# | SECTION 8.2 | REVIEW

**100 WOOLCOTT STREET**

**ALTERATIONS AND ADDITIONS  
TO A DWELLING HOUSE**

This Statement of Environmental Effects has been prepared to accompany a Section 8.2 review of the refusal of Development Application No. 879/2022 for alterations and additions to an existing dwelling at 100 Woolcott Street, Earlwood.

Figure 8: Front and rear elevations

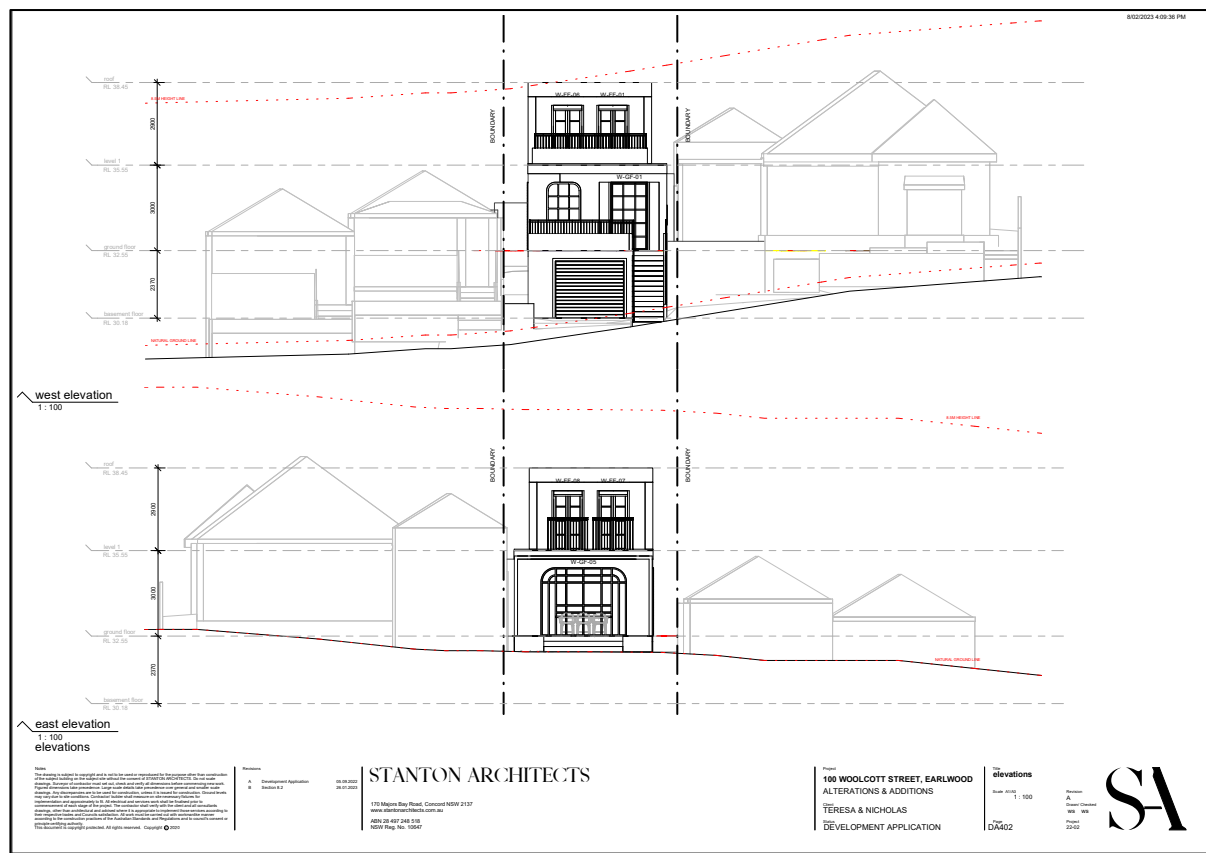
*In accordance with the Part 4, Clause 4.3(2) of the Canterbury Local Environmental Plan 2012 (CLEP), the proposed site requires that a dwelling house developed on this lot have a maximum building height of 8.5m. Hence, in accordance with Part C, C1, Section 1.3, C1.3.2, C1(b) of the CDCP, the required maximum wall height for this development is 7m. The submitted elevation drawings indicate the wall height of the proposed alterations and additions will exceed this requirement with a dimension of 7.4m to 7.6m above NGL. Therefore, the proposed wall height does not comply with this control.*

The additions remain lower in height than the dwelling to the south, thus respecting the slope of the land.

The additions display one storey above the roof of the dwelling to the north. This is not an unreasonable or jarring outcome having regard to the slope of Woolcott Street and what one would expect to see on topography such as this neighbourhood.

The variation of up to 600mm equates to an 8.6% variation which is not considered excessive in the context of the site.
